Re: Response to Comments | City of Portsmouth Wetland Conditional Use Permit Request | Tax Map 255, Lot 2 | 0 Banfield Road (with frontage on Peverly Hill Road), Portsmouth, New Hampshire

On behalf of the applicant, Chinburg Development, we are pleased to submit this response to comments and suggestions included in a July 3, 2025 Memo, from Kate Homet and Peter Britz, to the Conservation Commission Members in preparation for the July 9, 2025 meeting. The comments and suggestions are included below in *Italics*, followed by our responses in **Bold** text.

This application is for the installation of residential driveways, underground utility piping, and at-grade stormwater management BMPs for an undeveloped site that is to be subdivided and developed into five single-family residential properties. This project proposes 6,676 s.f. of permanent disturbance to the 100' wetland buffer.

GRADING PLAN
TAX MAP 255 - LOT 2

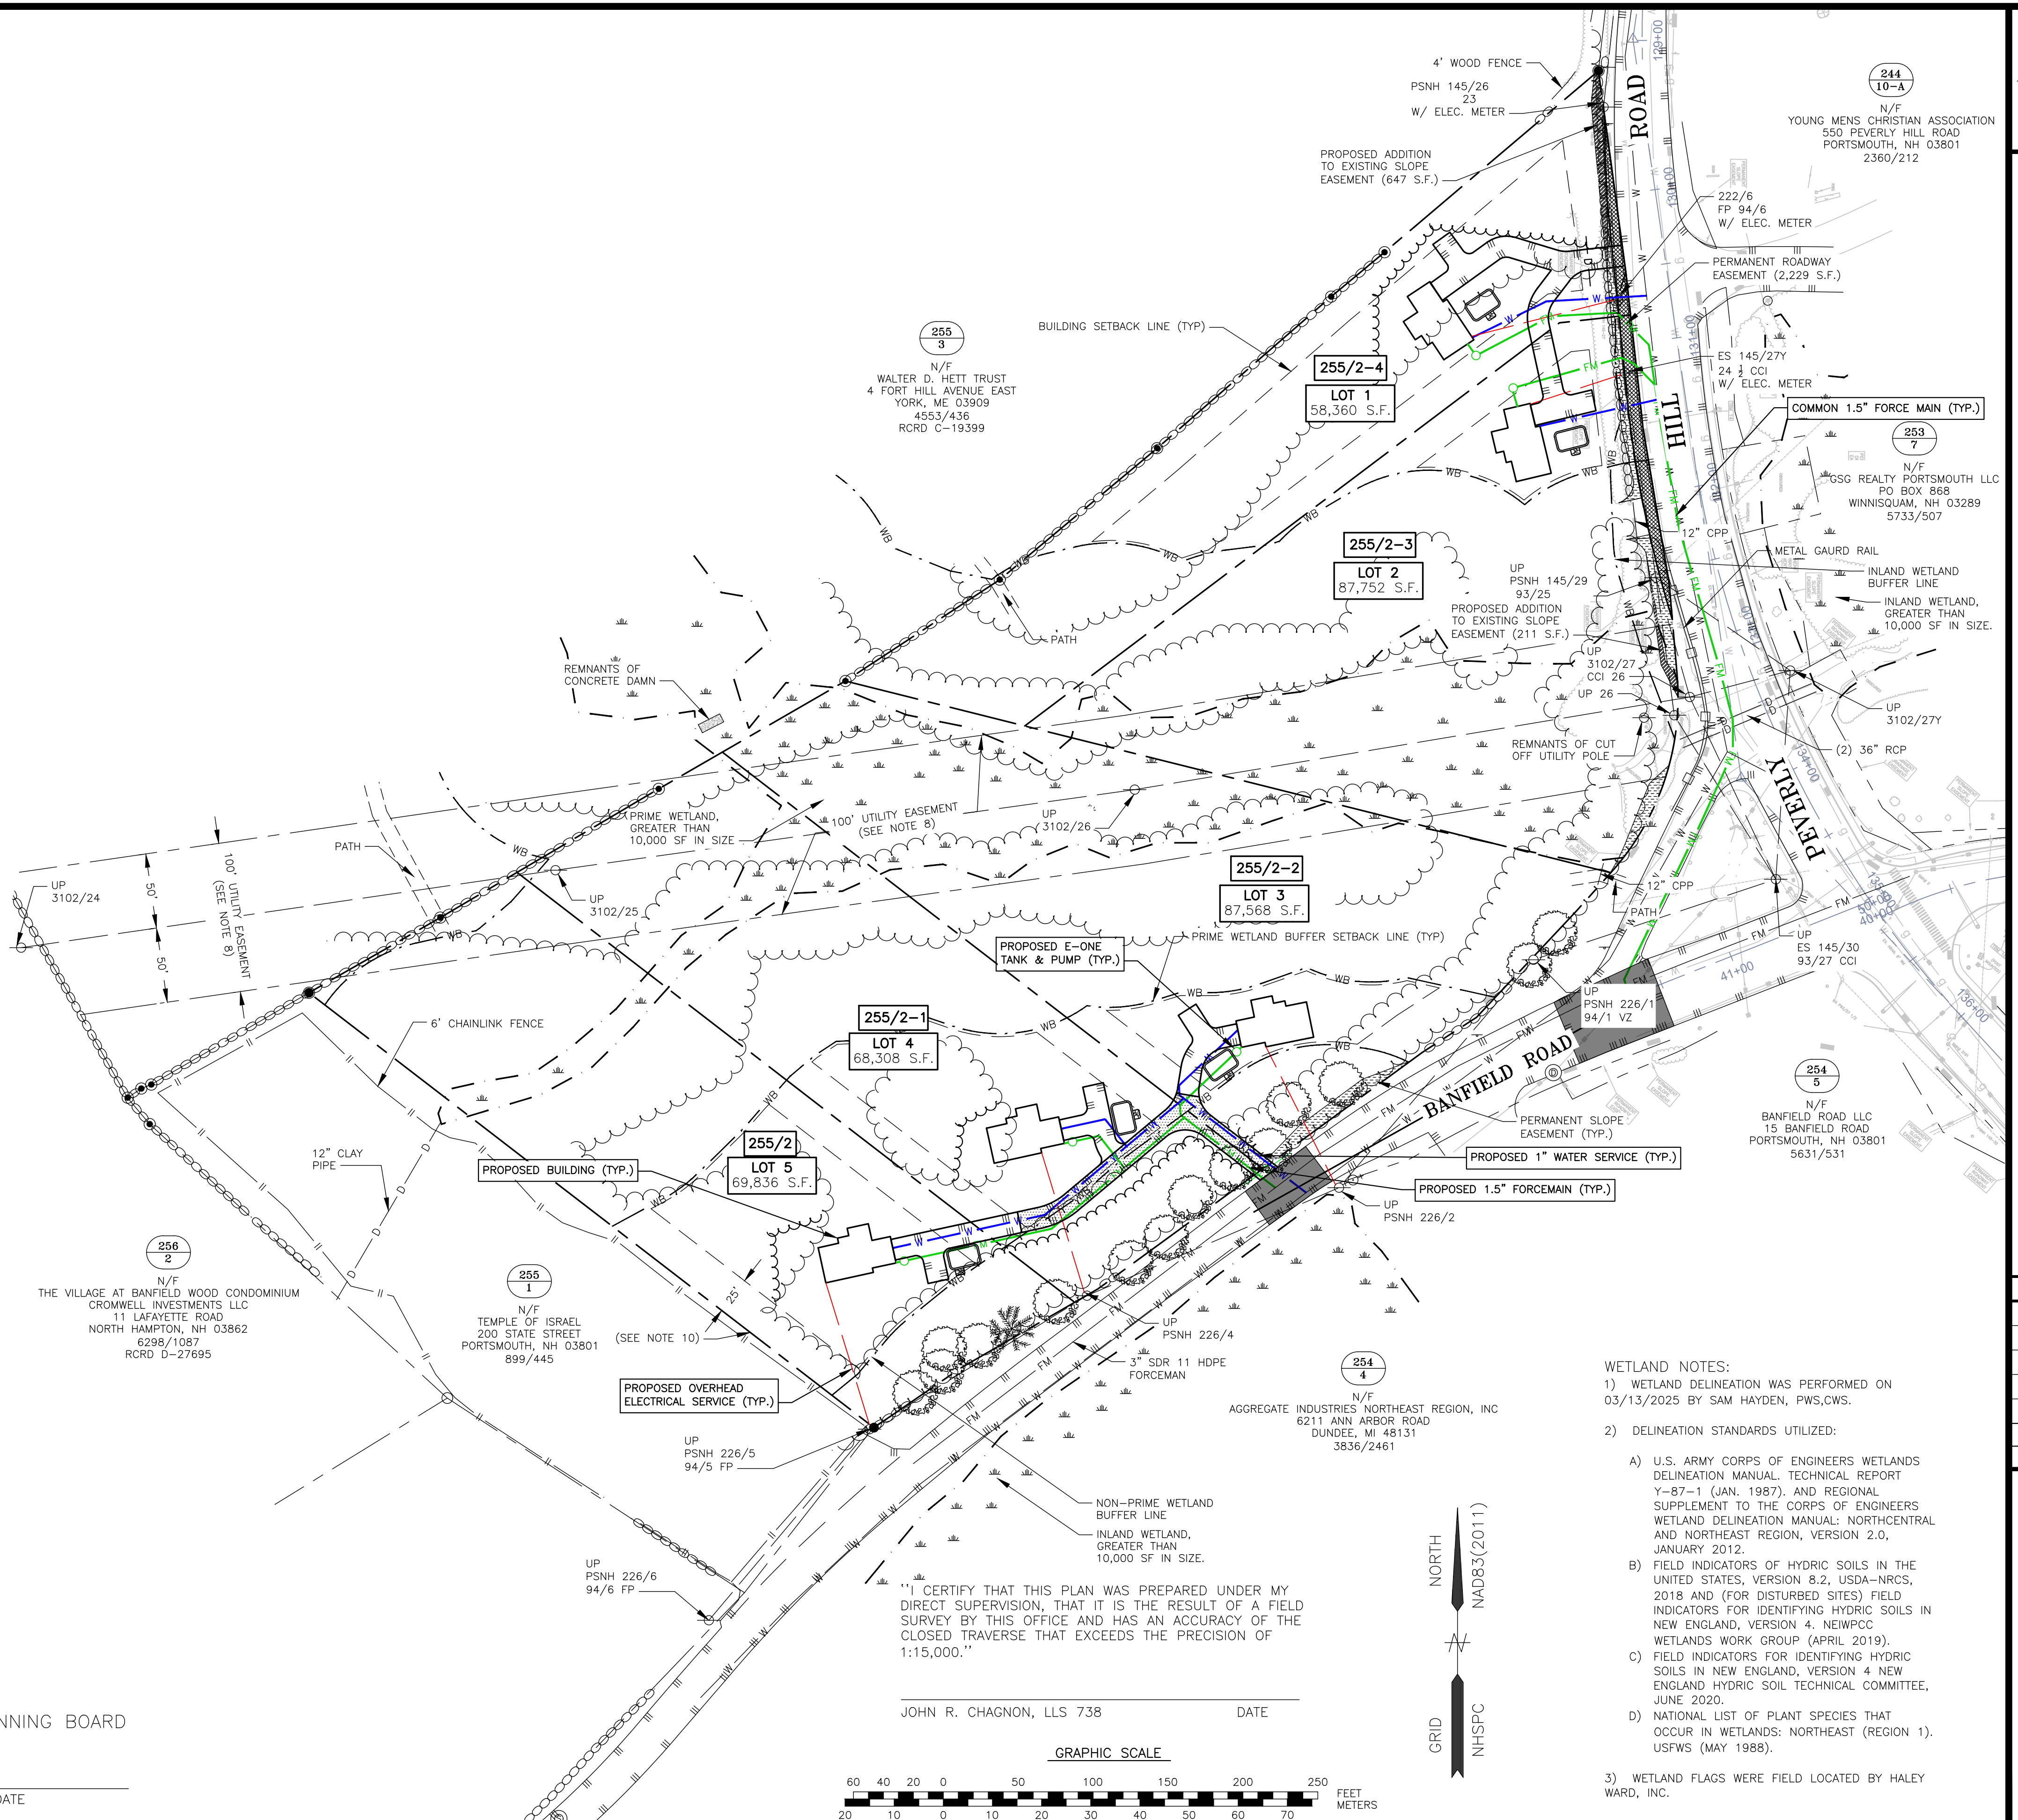
8. *Applicant must clearly define and address areas to be filled and areas to be regraded on the plans.*

The Grading Plan has been updated to show the proposed grading associated with the proposed driveway and single-family housing for each lot. Any changes in grade have been considered in the calculation of proposed wetland impacts.
